**Re: Jackson Hydroelectric Project, FERC No. P-2157
Side Channel Enhancements – Ramping Rate Evaluation Plan Supplement
License Article 405**

Side Channel Enhancements Ramping Rate Evaluation Plan Supplement

License Article 405

August 2014

Table 1. Downramping Rate Schedule, 600 to 300² cfs flow range, Reach 1, Lower Sultan River (per License Appendix G, A-LA 5).

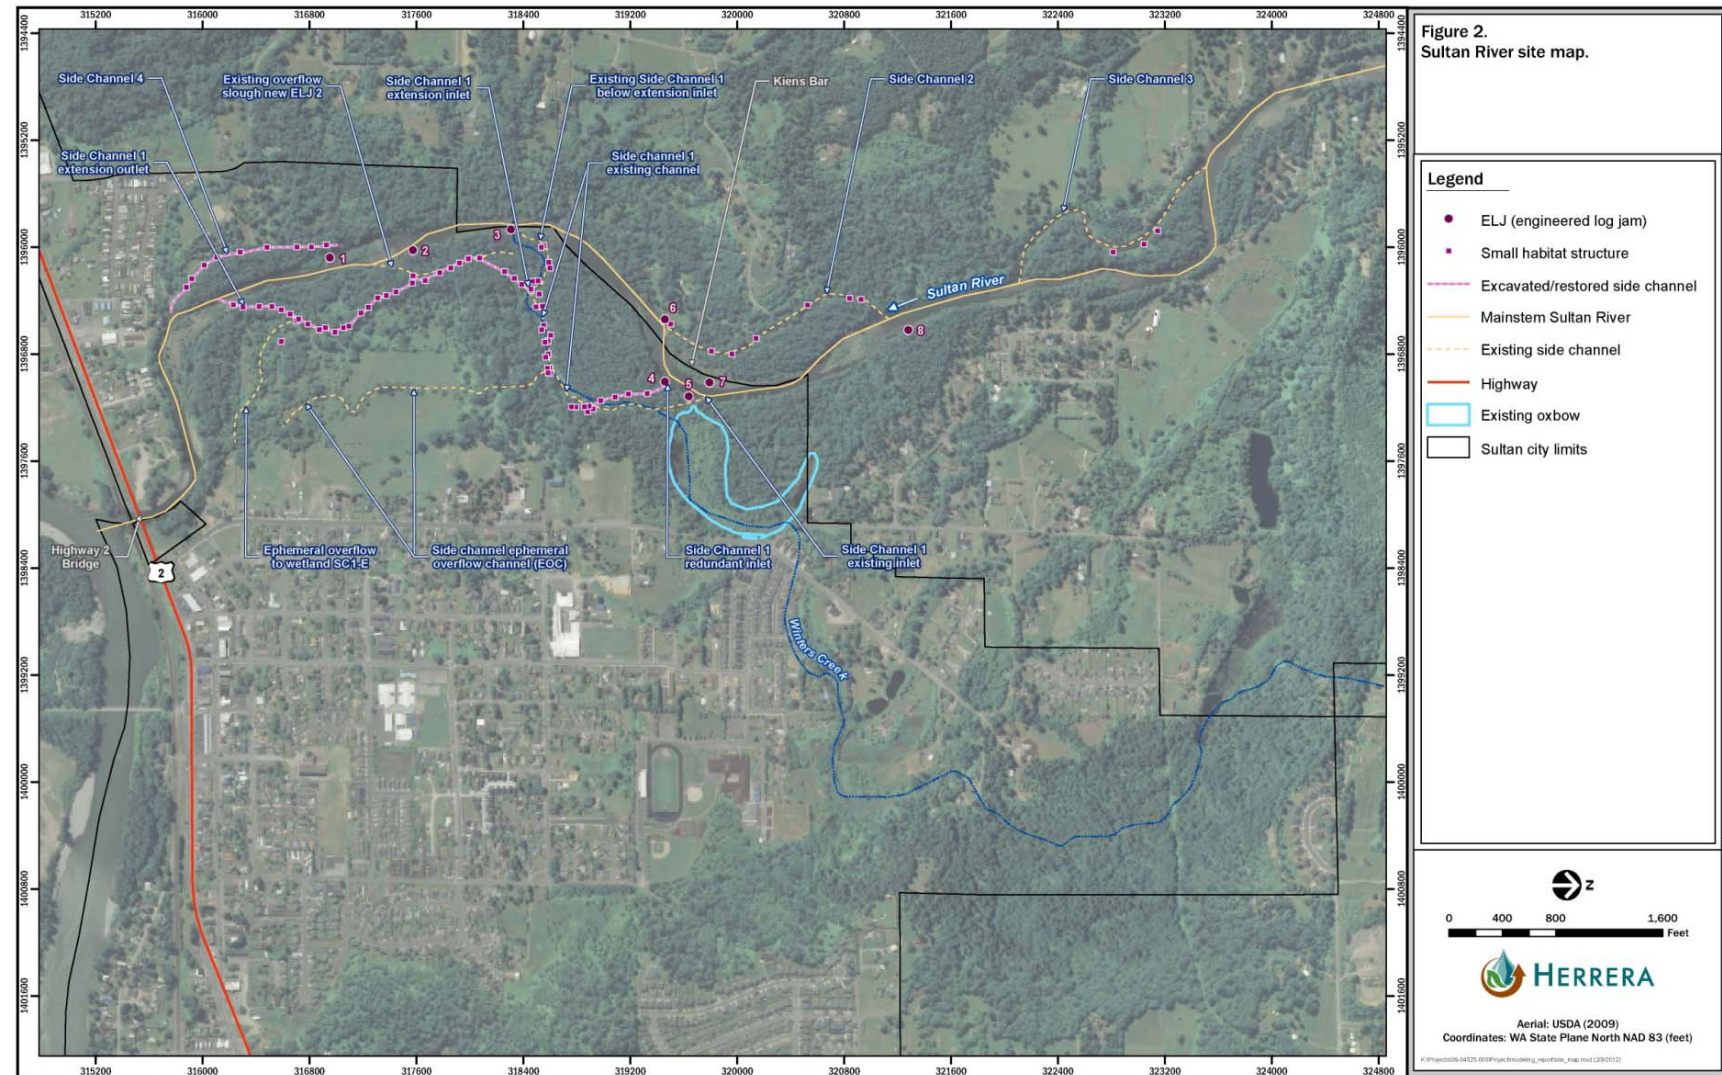
Comment [05]: What are the hydraulic controls within the sidechannels at flows higher than 600 cfs? This would be important to determine during months when the ramping rate is set for 4” per hour – at times when Coho are rearing in side channels – Nov-Dec and January – May. See yellow highlights in Table 1.
